MODIFICATION RECOMMENDED

N5244AS-01

S E R V I C E

N5244AS PNA Series Microwave Network Analyzers

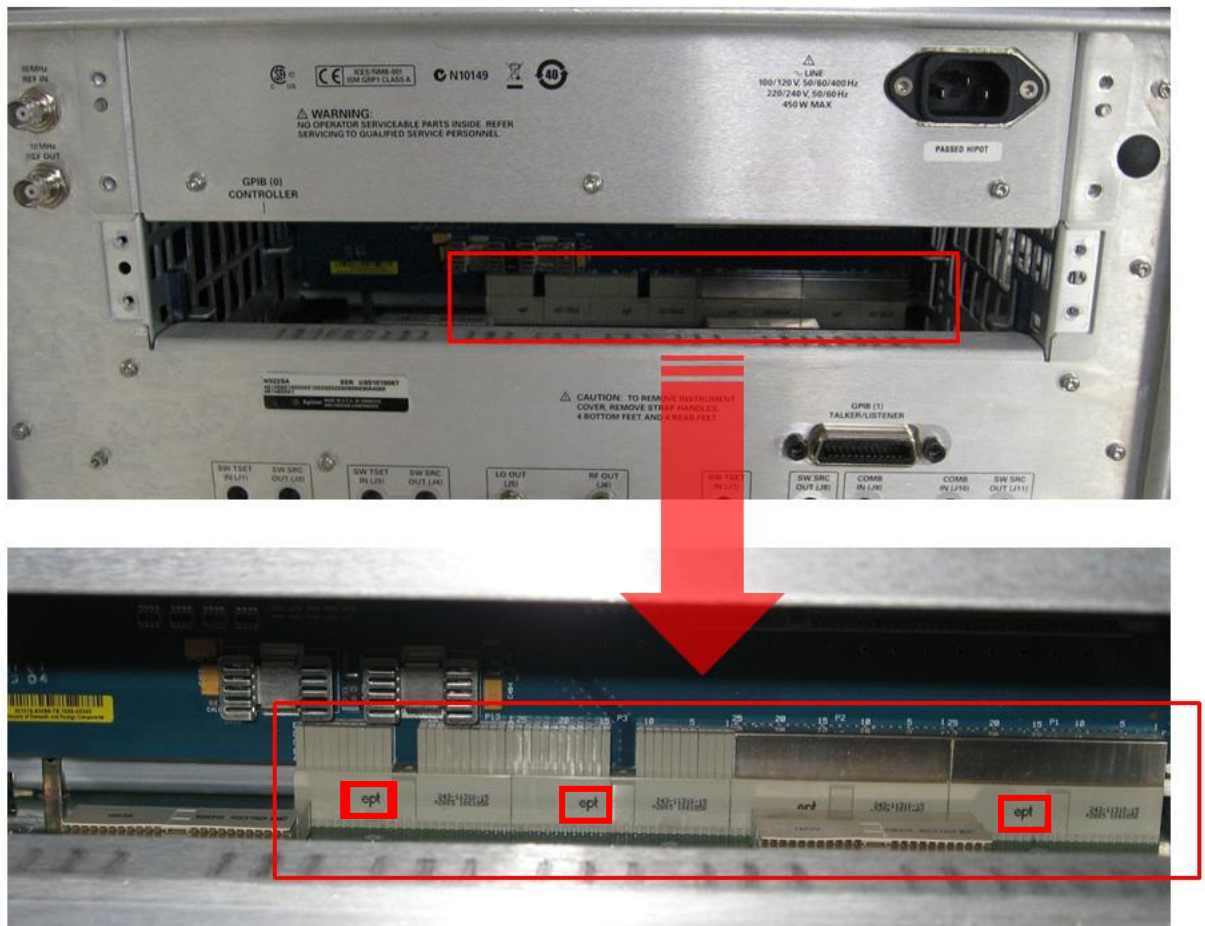
1. Remove the CPU assembly from the analyzer's rear panel. Refer to the PNA Service Guide chapter 7 section titled, "Removing and Replacing the CPU Board Assembly" for removal and reinstallation procedures. To view the online Service Guide, see the numbered list on the next page for instructions.
2. As per the photo below, inspect the system motherboard connector to see if it has one or more "ept" logos.

3. If the connector has one or more “ept” logos, return the analyzer to Agilent for replacement of the system motherboard. If the connector does not have one or more “ept” logos, email support_ctd-soco_support@agilent.com, providing the analyzer model and serial number and details of the malfunction symptoms.

4. *For Agilent Service Technicians only:* Only new boards without “ept” logos should be installed. Before installing the new board, look to see if it has one or more “ept” logos. If so, email support_ctd-soco_support@agilent.com, providing the analyzer model and serial number. Wait for further instructions in an email reply. New boards without “ept” logos can be installed.
For installation instructions, refer to the PNA Service Guide chapter 7 section titled, “Removing and Replacing the System Motherboard.” To view the online Service Guide, see the numbered list on the next page for instructions.
